UNITED STATES PATENT AND TRADEMARK OFFICE

APPLICATION NO.	FILING DATE	FIRST NAMED INVENTOR	ATTORNEY DOCKET NO.	CONFIRMATION NO.
10/724,009	11/26/2003	Jurgen Lindolf	INFN/0040	7545
46798	7590	09/13/2005	EXAMINER	
MOSER, PATTERSON & SHERIDAN, LLP GERO G. MCCLELLAN/INFINEON 3040 POST OAK BLVD., SUITE 1500 HOUSTON, TX 77056			HO, TU TU V	
			ART UNIT	PAPER NUMBER
			2818

Office Action Summary

DETAILED ACTION

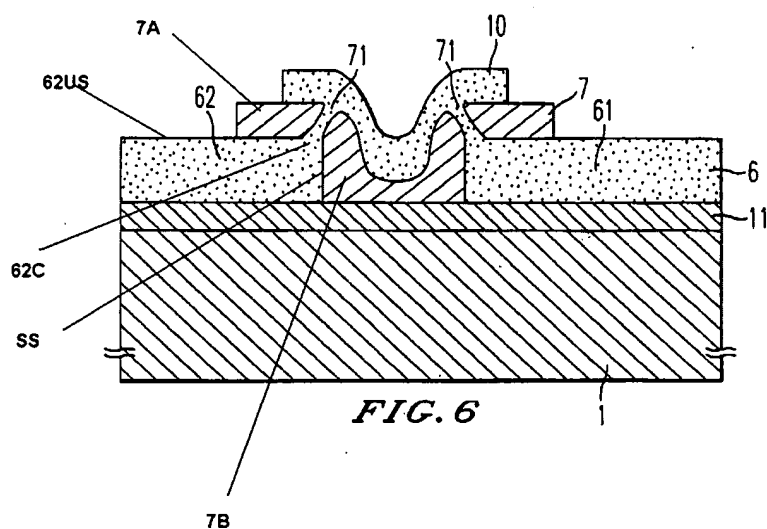
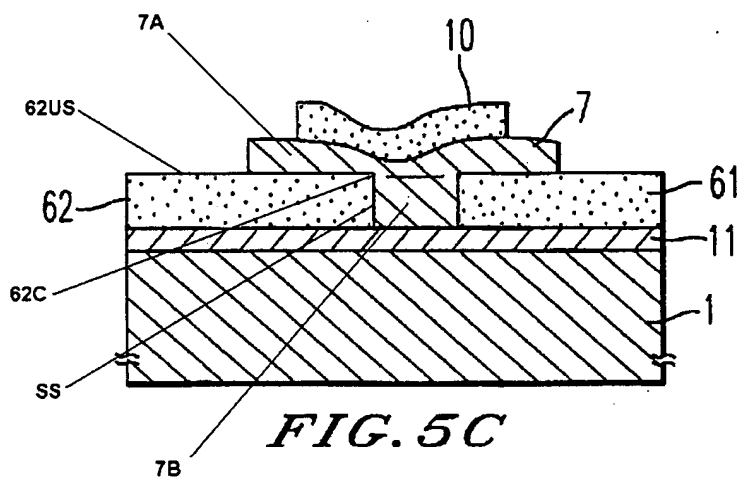
Specifically, Takagi discloses a single region 7 that is functionally equivalent to the nonconductive region 2 and the dielectric layer 4 of the present invention. More specifically and with reference to Figs. 5C and 6, with added reference characters as depicted on the following page for ease of explanation, Takagi discloses an antifuse, comprising:

a first conductive region (62), the first conductive region defining a first upper surface (62US) and a first lateral boundary surface (SS) which meet at an angle (62C) to form an edge;

a nonconductive region (7B) adjoining the first conductive region (62), the nonconductive region defining a second upper surface and a second lateral boundary surface

(SS); wherein the first and second lateral boundary surfaces are in facing relationship and form an interface (generally indicated as SS);

a dielectric layer (7A) disposed over at least a portion of the first upper surface (62US) of the first conductive region and at least a portion of the edge (62C), whereby an area of relatively increased field strength is produced during application of a programming voltage to form a

breakdown channel (71) in the dielectric layer; and a second conductive region (10) on the dielectric layer.

As noted, Takagi discloses a single region 7 that is functionally equivalent to the nonconductive region 2 and the dielectric layer 4 of the present invention. Although the claimed invention is not identically disclosed or described by Takagi, the subject matter as a whole would have been obvious at the time the invention was made to a person having ordinary skill in the art to which said subject matter pertains. The subject matter as a whole, providing a dielectric region (7) including a dielectric portion (7A) and a nonconductive region (7B), as disclosed by Takagi, or providing a dielectric region including a dielectric layer (4) and a nonconductive region (2), as claimed, so that an area of relatively increased field strength is produced during application of a programming voltage to form a breakdown channel in the dielectric portion (7A) or dielectric layer (4) would have been obvious at the time the invention was made to a person having ordinary skill in the art to which said subject matter pertains, simply because neither variation, namely providing a dielectric region (7) including a dielectric portion (7A) and a nonconductive region (7B), as disclosed by Takagi, or providing a dielectric region including a dielectric layer (4) and a nonconductive region (2), as claimed, produces a product that is a newer or a useful improvement thereof over the other.

Referring to **claims 15, 30, and 37**, Takagi further discloses that the conductive region (62) defines a comer (62C) and wherein forming the dielectric layer (7A) comprises forming the dielectric layer over the comer. Referring to the limitation “area of relatively increased field strength” of claim 37, the area of relatively increased field strength results in the breakdown of the dielectric layer 7A at the corner and the eventual forming of the path 71).

Referring to **claim 16**, Takagi further discloses that the first conductive region (62) and the nonconductive region (7B) form a substantially planar upper surface which interfaces with a lower surface of the dielectric layer (7A, best seen in Fig. 5C).

Referring to **claims 18-20, 34, and 45**, Takagi further discloses that the nonconductive region (7B) comprises SiN and the dielectric layer (7A) comprises SiN (column 6, lines 61-63).
